**CITY OF BEND PLANNING DIVISION
STAFF FINDINGS AND RECOMMENDATION
TO THE PLANNING COMMISSION**

PROJECT NUMBERS: PZ-18-0883 (Waterway Overlay Zone Application)
PZ-18-0884 (Class B Variance Application)

REQUEST: Type III Waterway Overlay Zone (WOZ) and Class B Variance application
for a single-family dwelling with a 5 foot front setback (standard of 20 feet;
75 percent reduction) in the Residential Standard Density (RS) Zone.

Section 2.7.640 Flood Plain Combining Zone

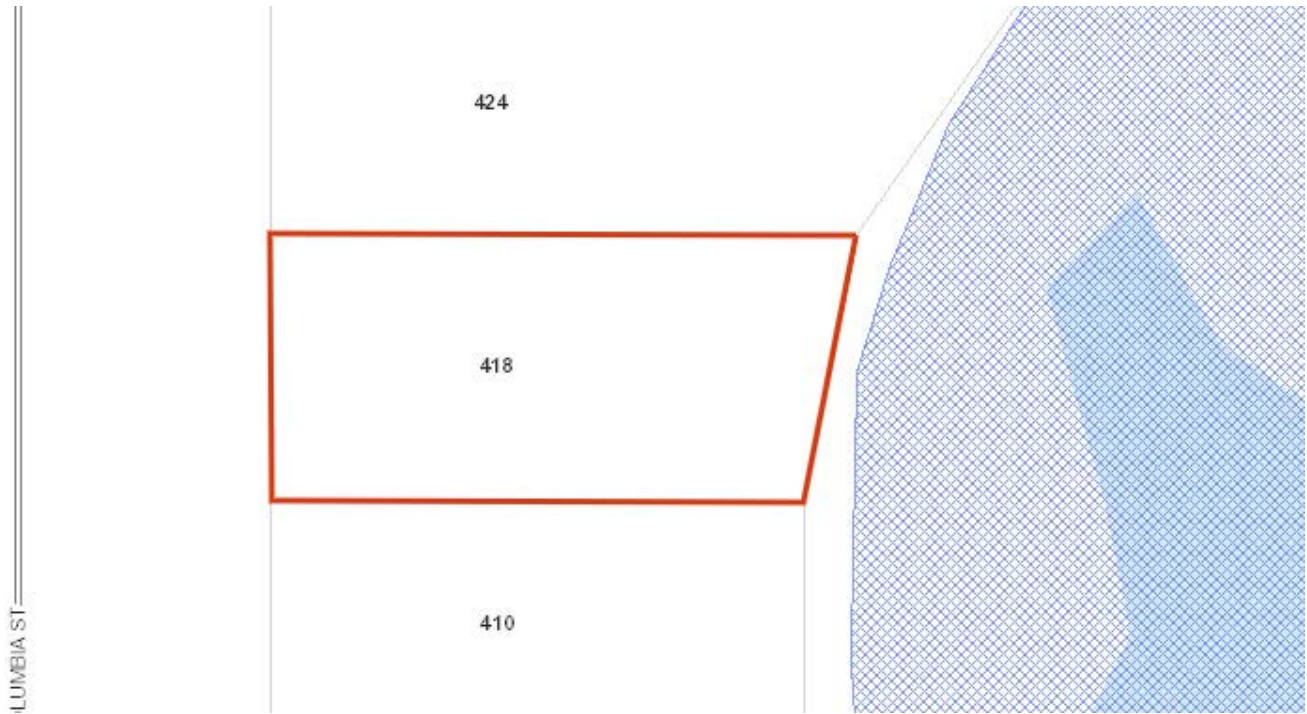
FINDING: The 100-year flood plain is depicted below as a crisscross blue pattern. It coincides roughly with the east property line of the subject property, and the proposed 3-story house is located well above the base flood elevation.

East Elevation

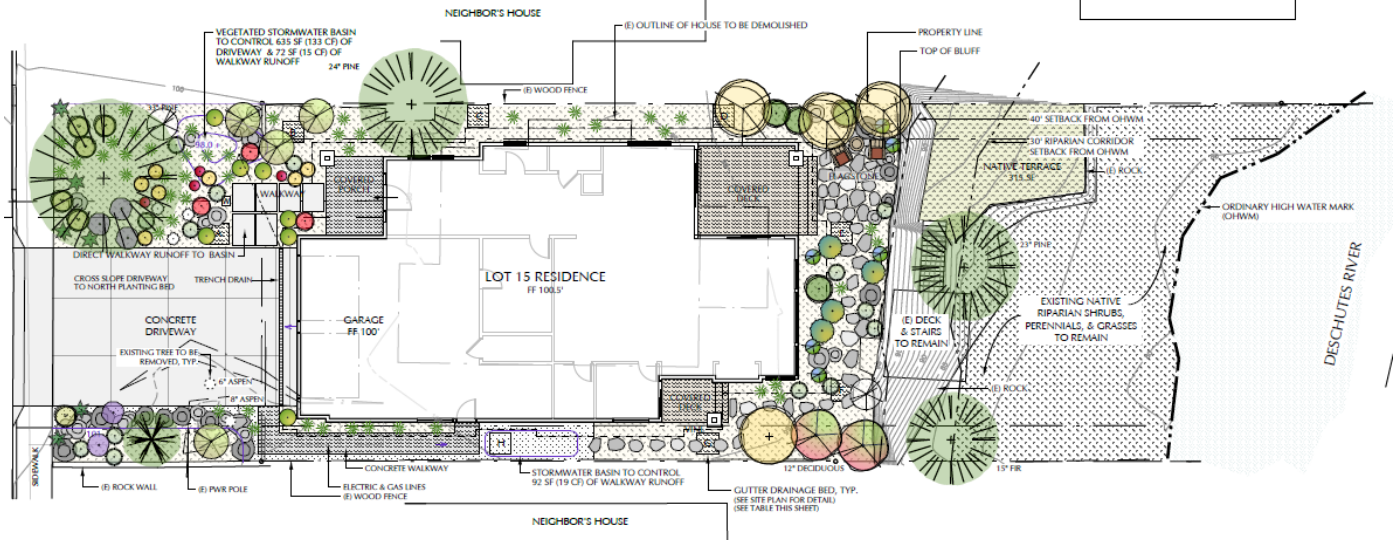
FINDING: The proposed 3-story structure will be located more than 40 feet back from the Ordinary High Water Mark, and will be compliant with the height standard of the underlying (RS) zone following the alteration of the proposed elevations. As reviewed above, the proposed height is currently at 30.5 feet, however, staff recommends allowing the applicants flexibility in either removing the top (3rd) story of the home or slightly altering the height of each floor to stay at or under the 30-foot threshold. Provided the aforementioned condition of approval is established, this standard will be met.

Height: The height of the home as proposed is approximately 30.5 feet tall, exceeding the standards of the RS zone. Provided a condition of approval is established to require minor alterations to the elevations, a 30-foot height can be achieved with relative ease. A 30-foot tall structure is permissible in the RS zone, and there are similar residence including the property to the south that was approved with a 28-foot height. The location of the third story, with a smaller footprint and further setback of approximately 85 feet to the OHWM, reduces the appearance of height.

3. The applicants must, before submission for building permits, update the building elevations to demonstrate a compliant building height (30 feet or less) per the City's definition and methodology of building height in BDC Chapter 1.2.
